Project	IEEE 802.16 Broadband Wireless Access Working Group < http://ieee802.org/16 >	
Title	Femtocell Base Station State Diagram	
Date Submitted	2009-05-02	
Source(s)	Andreas Mäder, Linghang Fan, Tetsu Ikeda NEC Rong-Terng Juang, Pang-an Ting, Yu-Tao Hsieh, Fang-Ching Ren ITRI Hsin-Piao Lin NTUT	E-mail: andreas.maeder@nw.neclab.eu linghan.fan@eu.nec.com t-ikeda@ap.jp.nec.com rtjuan@itri.org hplin@ntut.edu.tw
Re:	Category: SDD comments / Area: Chapter 15 (Femtocell)	
Abstract	The contribution provides a clarifying state diagram for femtocell base stations	
Purpose	To be discussed and adopted by TGm for the 802.16m SDD	
Notice	<i>This document does not represent the agreed views of the IEEE 802.16 Working Group or any of its subgroups. It represents only the views of the participants listed in the "Source(s)" field above. It is offered as a basis for discussion. It is not binding on the contributor(s), who reserve(s) the right to add, amend or withdraw material contained herein.</i>

Femtocell Base Station State Diagram

Section 15.X Femtocell BS State Diagram

Figure XX: State transition diagram of Femtocell BSs

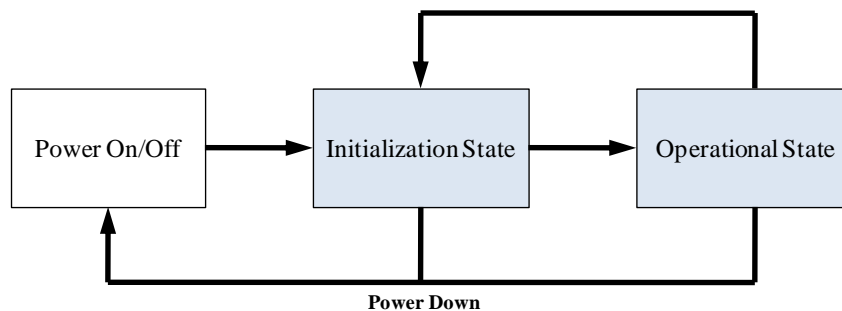
Figure XX illustrates the Femtocell BS state diagram. The state diagram contains an initialization and operational state.

Figure YY: Femtocell BS initialization state

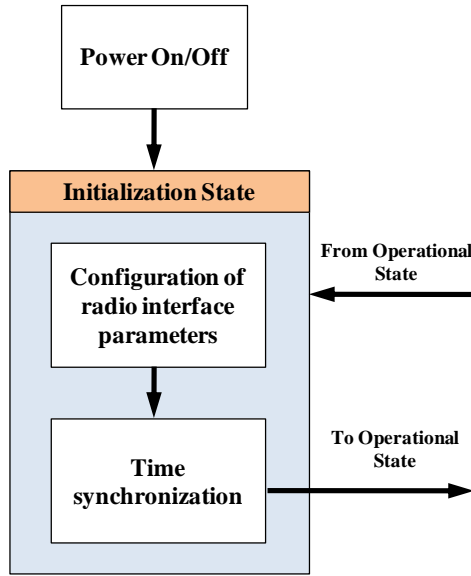
In the initialization state, procedures like configuration of radio interface parameters and time synchronization may be performed. See Figure YY for a graphical representation.

Figure ZZ: Femtocell BS operational state

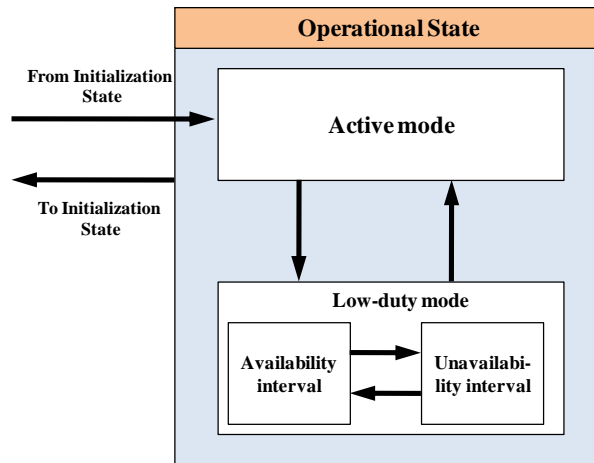
After successfully attaching to the network, a femtocell BS enters the operational state. In the operational state, two operational modes may be supported: active mode and low-duty mode. In the low duty mode, availability intervals alternate with unavailability intervals. See Section 15.Y for further Details.
